Subject: New F53 Dispenser Firmware for U-Scan

Overview

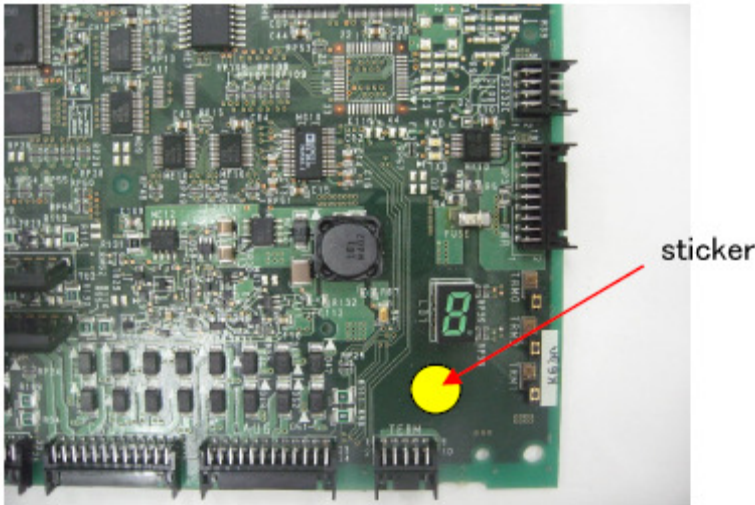
All new F53 units and spare boards listed below ordered after cut-in will have a yellow sticker on the board, as shown below, to indicate that US0300 firmware has been loaded. Spare PCB boards should be ordered using the new part number KD03234-K900 so that they come with the correct firmware. All units upgraded in the repair center will have the sticker applied.

KD03234-K900 F53 Bill Dispenser PCB, US0300 FW
